Under the Resource Management Act 1991
In the matter of Notices of Requirement to enable the construction, operation and
maintenance of the City Rail Link

Statement of Evidence of Matthew James Harrison

12. My role in the CRL project team includes:
 - (a) Leading the review of the vibration and regenerated noise assessments undertaken by Marshall Day Acoustics Ltd (MDA) for the construction and operation of the CRL.

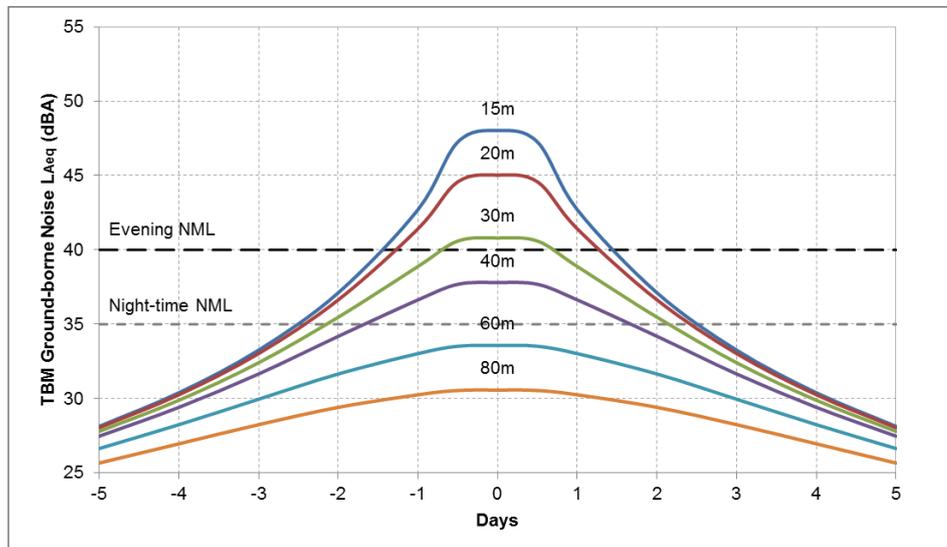
36. The following graphs, extracted from Section 4.3 of the above mentioned document, shows the approximate slant distances required to achieve the night-time noise criteria for various vibration producing items of plant and the likely duration of impact for a TBM progressing at approximately 20m/day. The first graph below shows that approximately 30 m is required for the Roadheader and 55 m for the

TBM to generate noise levels at the night-time regenerated noise level criterion of 35 dBA. The second graph shows that a TBM operating at a slant distance of as little as 25 m will exceed the night time noise criterion for approximately 3 days.

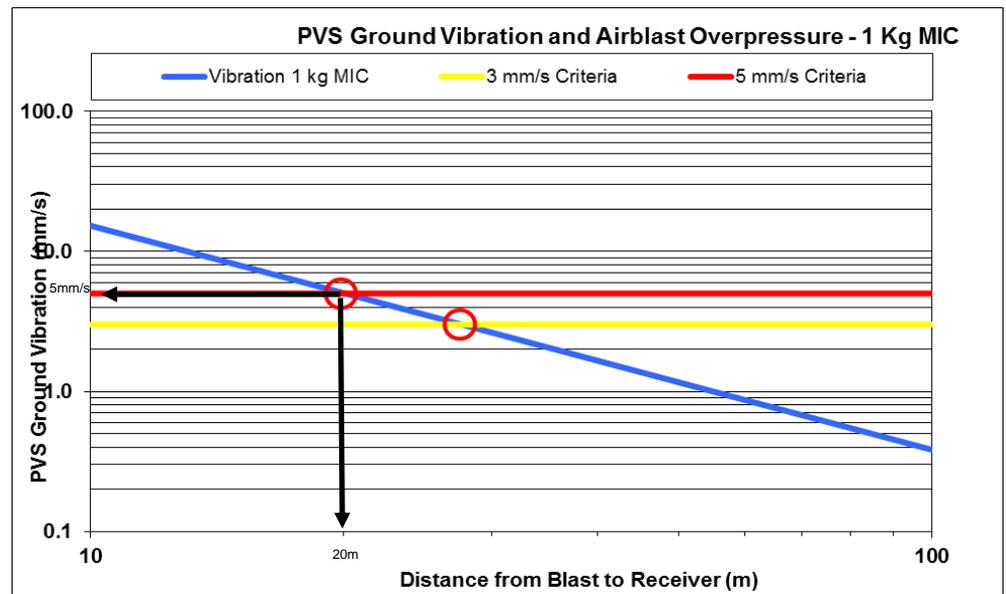
37. It is also relevant to note that our own preliminary assessment of regenerated noise in TV3 due to the construction activity, namely the Roadheader at approximately 15 m, results in a noise level of 41 dBA and 0.25 mm/s. It is possible that the noise monitoring at TV3 will indicate that noise at this level is already present in the Studios (from sources such as data projectors) and may well be tolerated for the relatively short period of time that they occur.
